971 Richmond Road, Marsden Park

ISSUE E - AMENDMENTS - 15.07.21

DEVELOPMENT APPLICATION

Proposed Mixed Use Development

Title
Level 03-04 - Block A

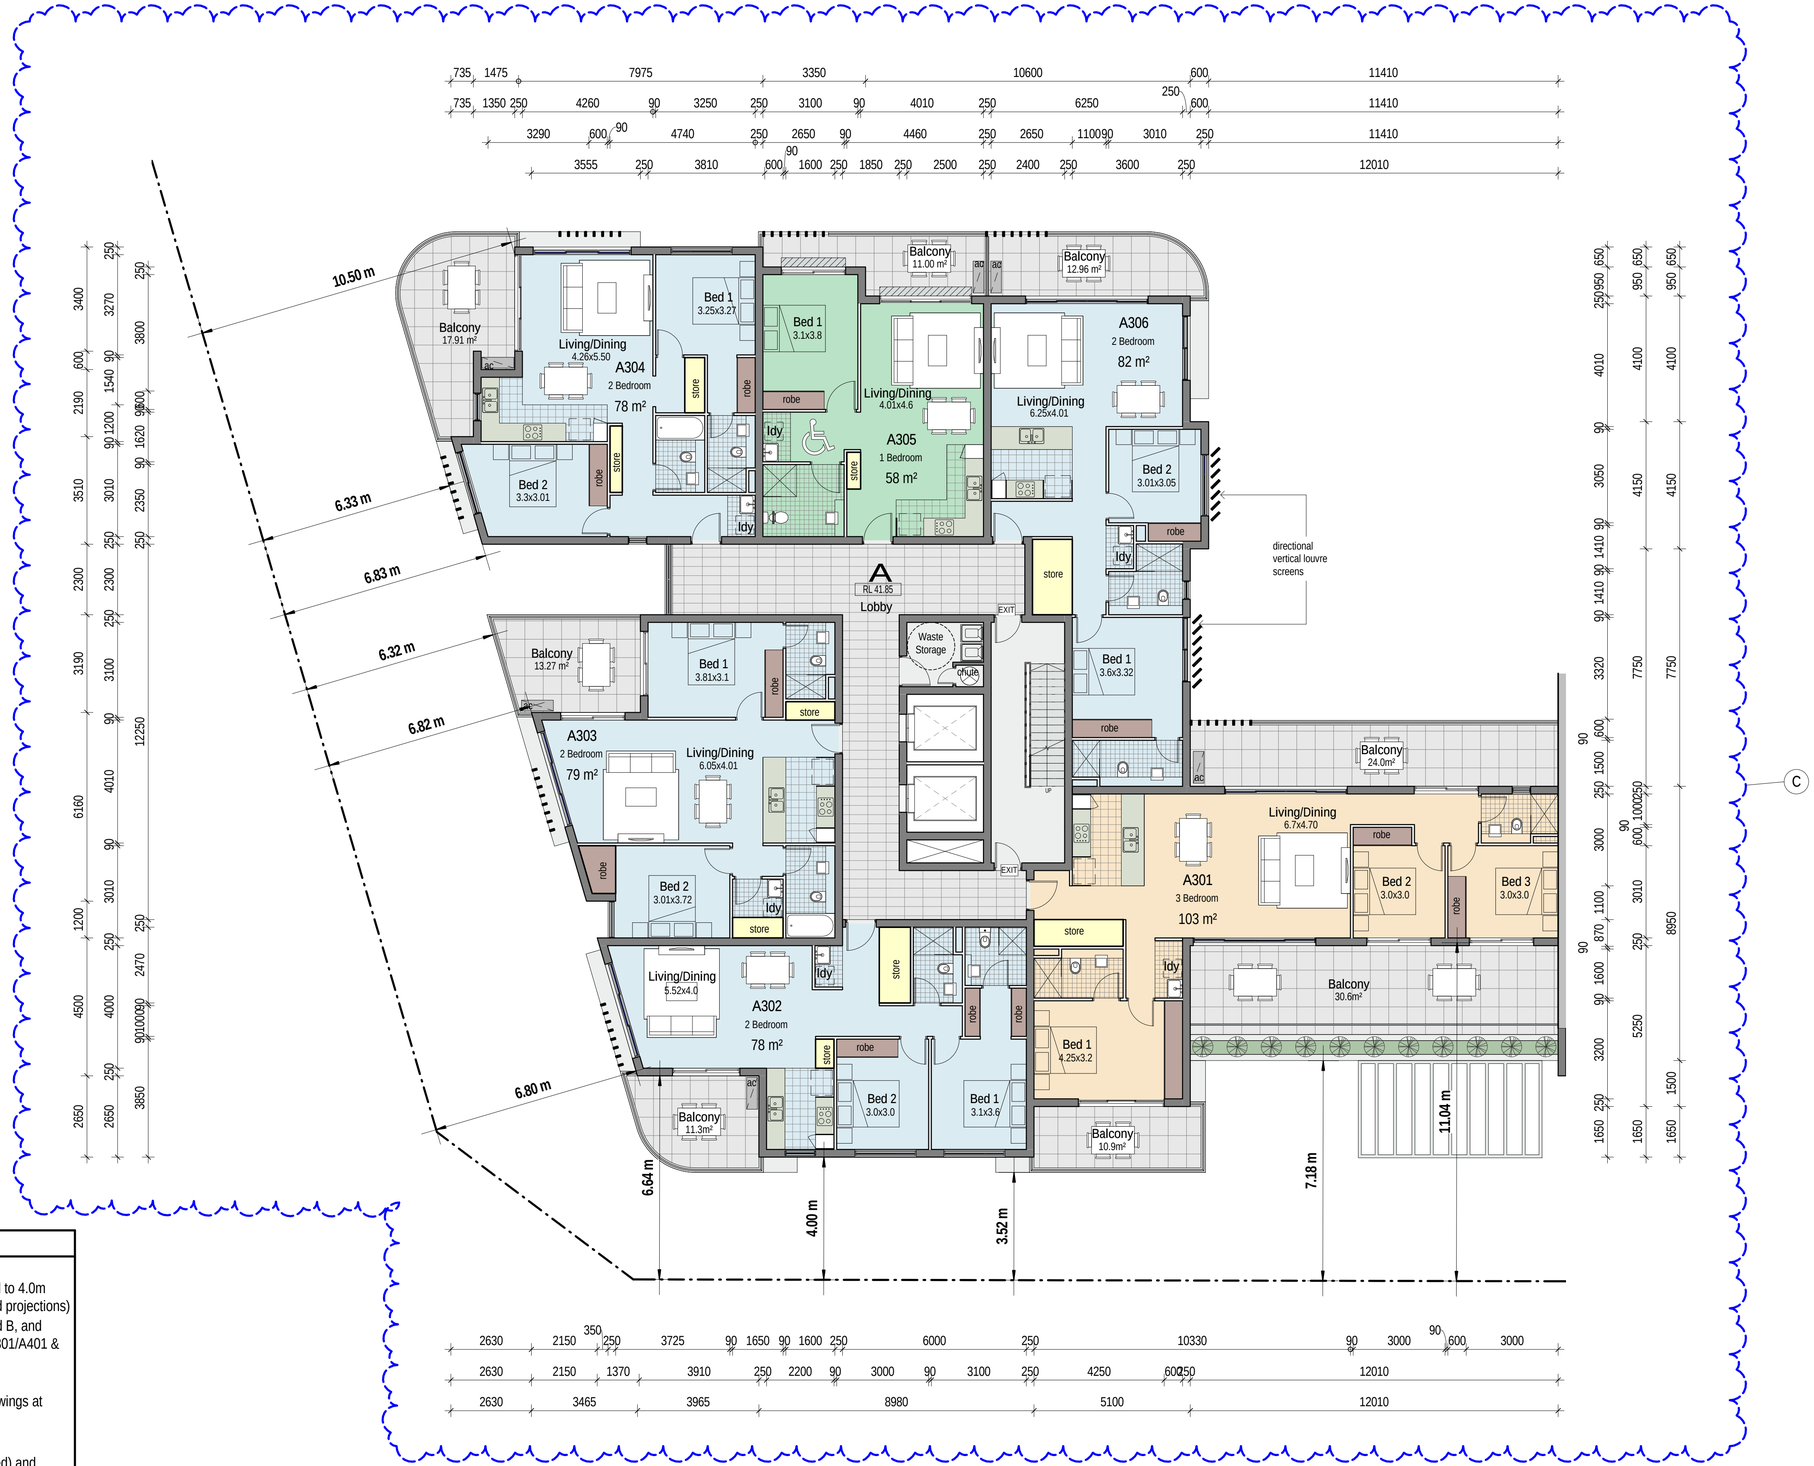
1. Lot 1 boundaries amended
2. Setbacks to Southern boundary adjusted to 4.0m minimum to building (3.5m to balconies and projections)
3. Bridging elements between Blocks A and B, and Blocks B and C increased in width Units A301/A401 & B306/B406 amended
4. Privacy Screens Added & noted
5. RLs amended to reflect revised Civil drawings at Ground Floor.
6. Additional dimensions shown.
7. Block A – Southern units A301/401 (3 bed) and A302/402 (2 bed) have been reconfigured.

1 Roof Level - Block A

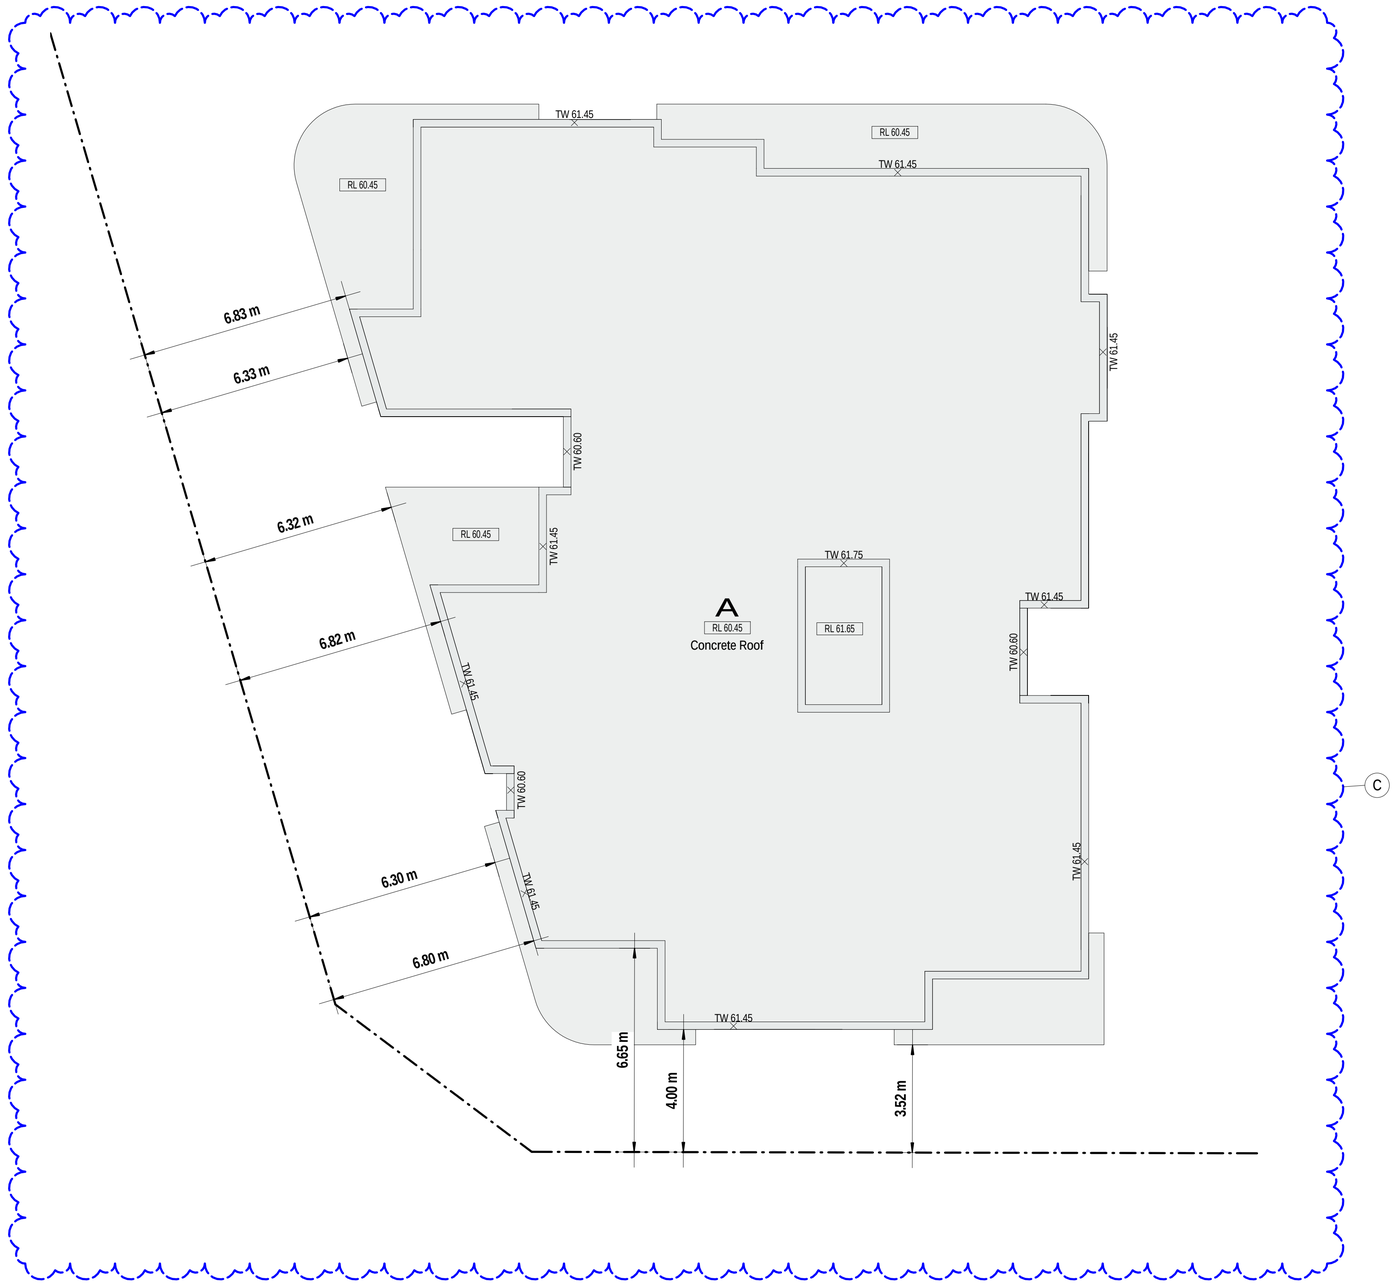
ISSUE C - AMENDMENTS - 15.07.21
1. Roof Plan amended to follow changes in floor plans below 1. RLs amended to reflect revised Civil drawings at Ground Floor. 2. Additional dimensions shown.

1 Level 02 - Block B

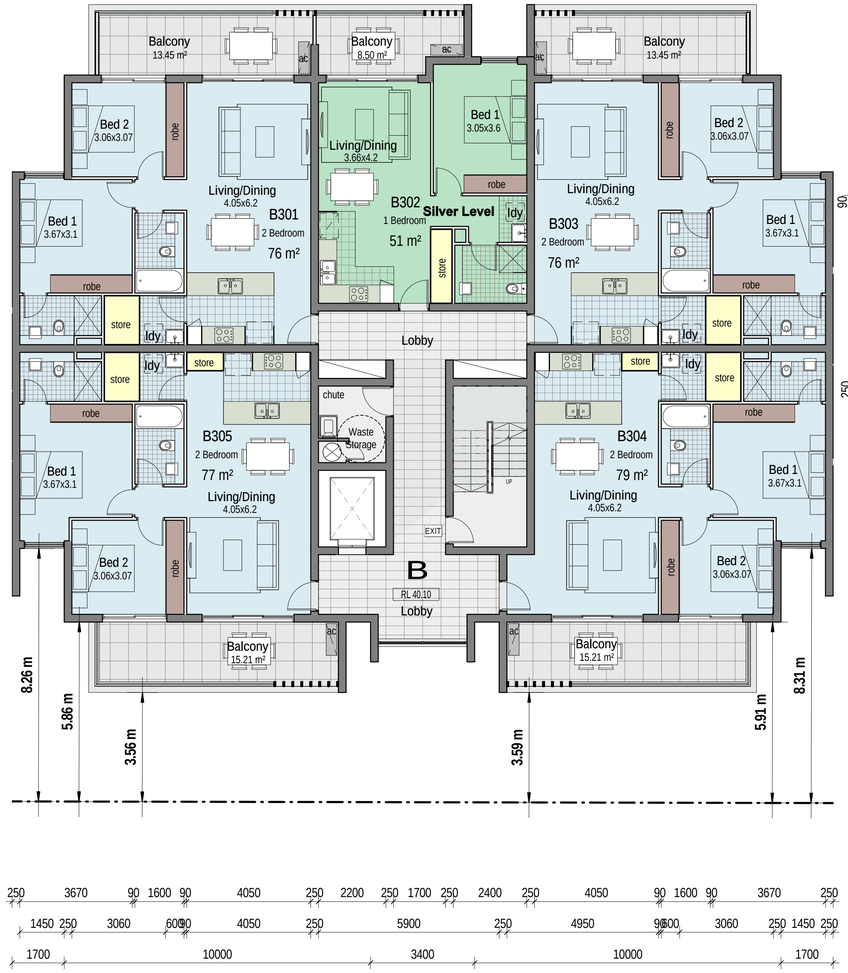
1. Lot 1 boundaries amended
2. Building below Setback 20m from Richmond Road - courtyards amended
3. Setbacks to Southern boundary adjusted to 4 metres minimum
4. Privacy Screens Added & noted
5. RLs amended to reflect revised Civil drawings at Ground Floor.
6. Additional dimensions shown.

1 Level 05-07 - Block B

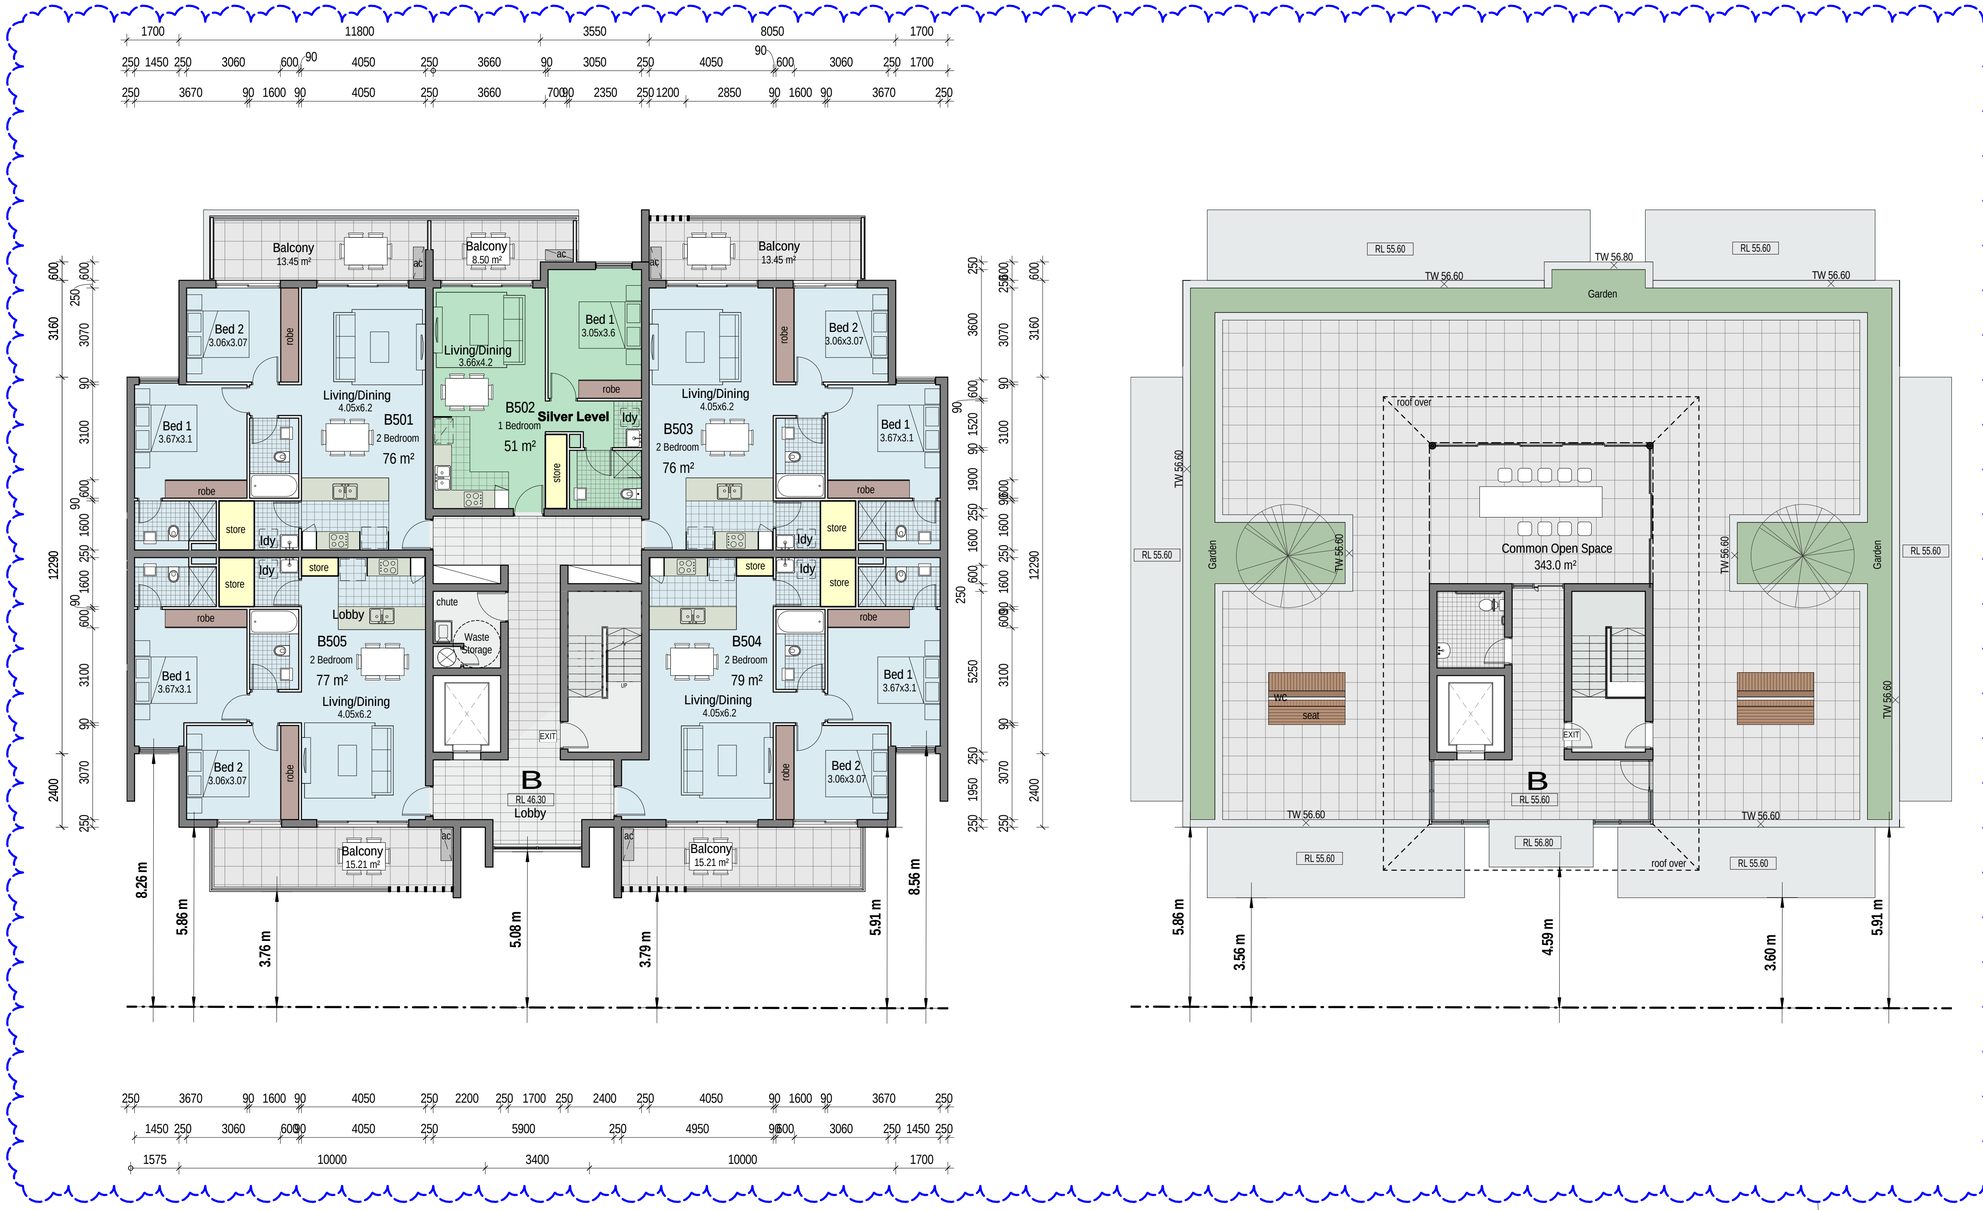
1. Lot 1 boundaries amended
2. Roof over bridging elements between Blocks A and B, and Blocks B and C amended to reflect amendments to units below
3. Setbacks to Southern boundary adjusted to 4.0m minimum to building (3.5m to balconies and projections)
4. Privacy Screens Added & noted
5. RLs amended to reflect revised Civil drawings at Ground Floor.
6. Additional dimensions shown.
7. Block B Landscape Design amended.

1 Level 05 - Block D

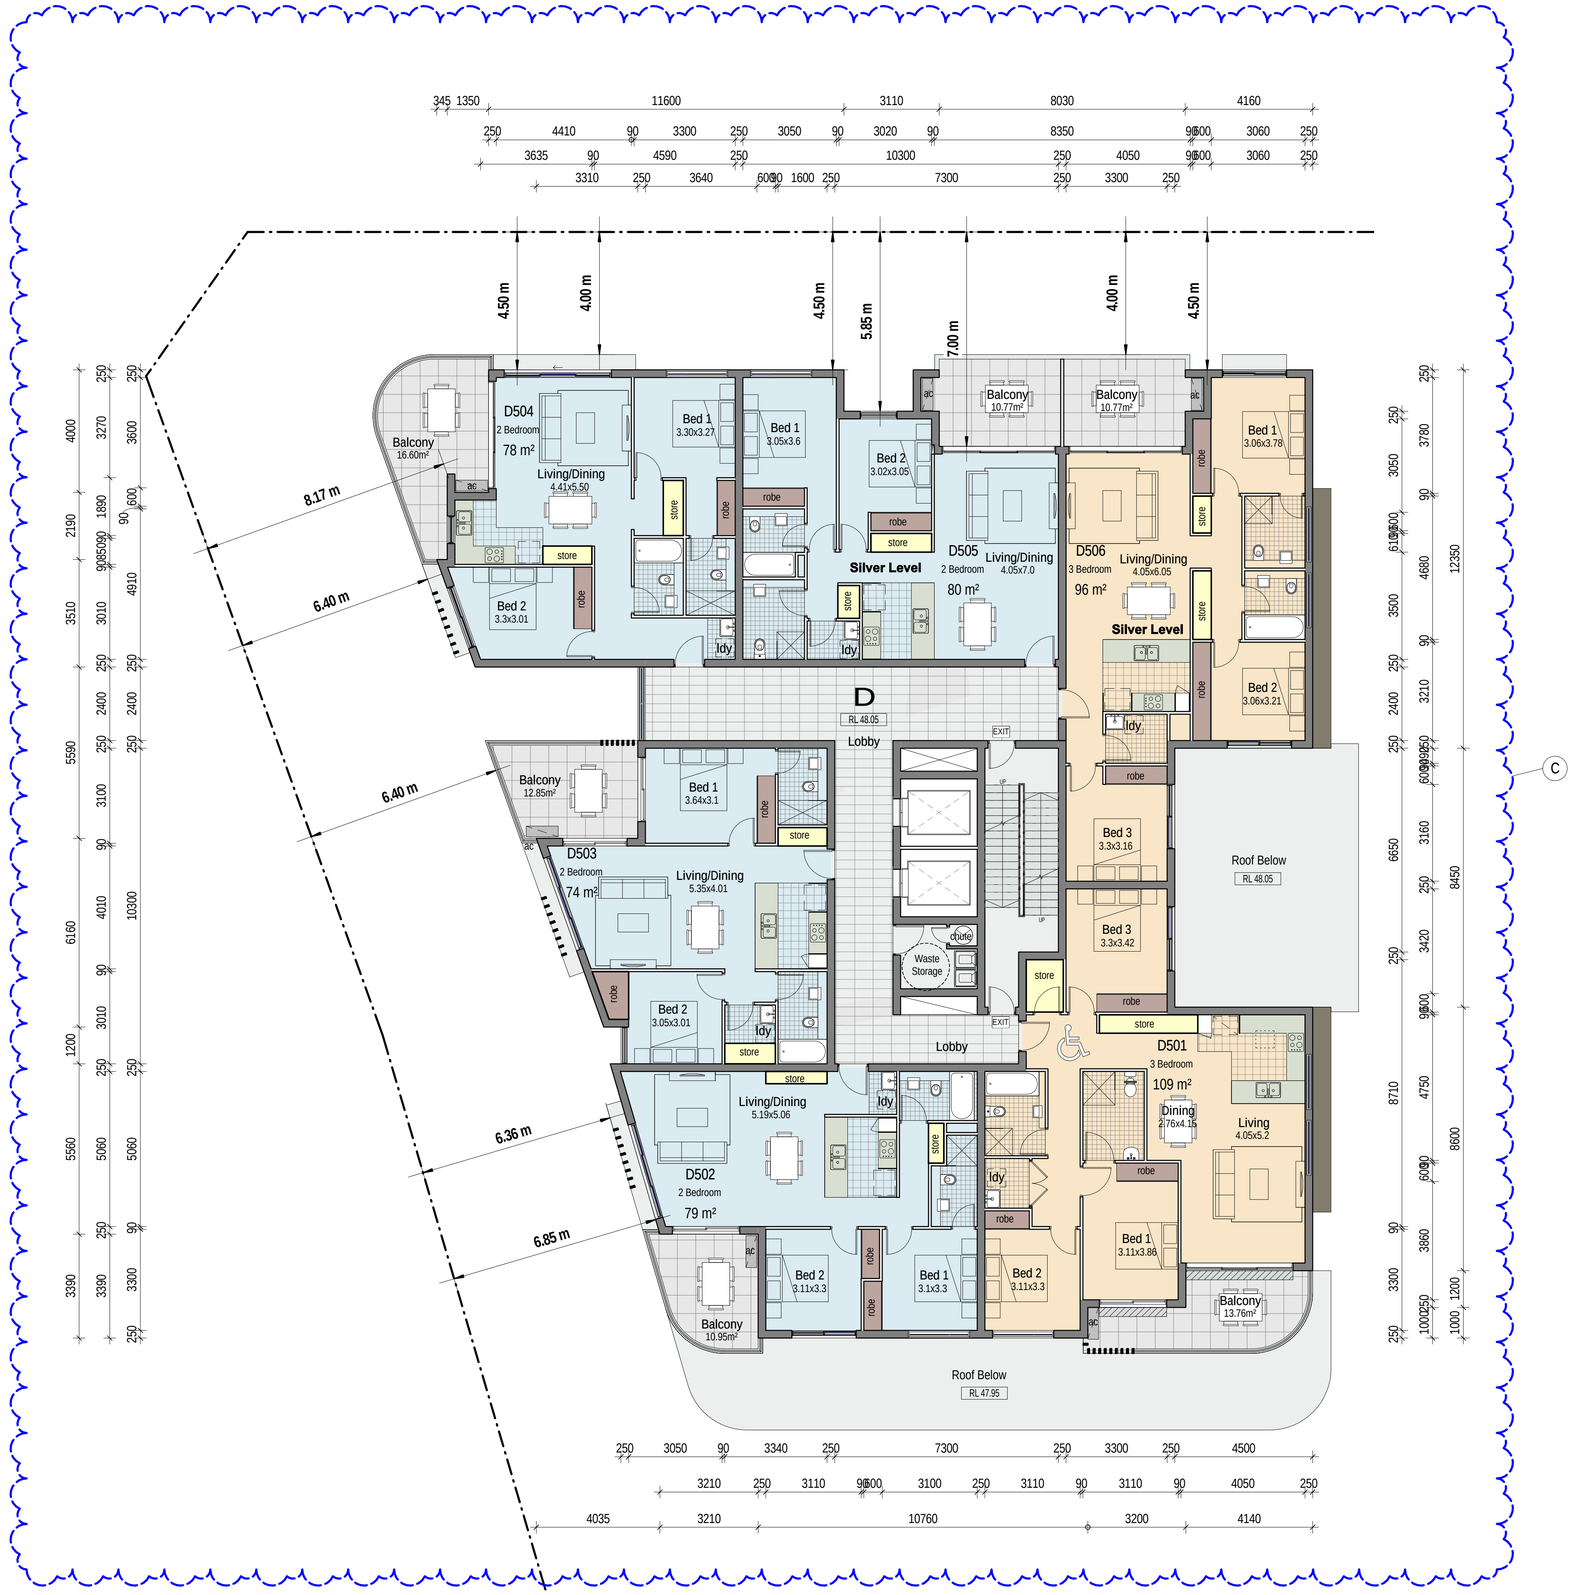
1. Lot 1 boundaries amended
2. Setbacks to Southern boundary adjusted to 4.0m minimum to building (3.5m to balconies and projections)
3. Privacy Screens Added & noted
4. RLs amended to reflect revised Civil drawings at Ground Floor.
5. Additional dimensions shown.
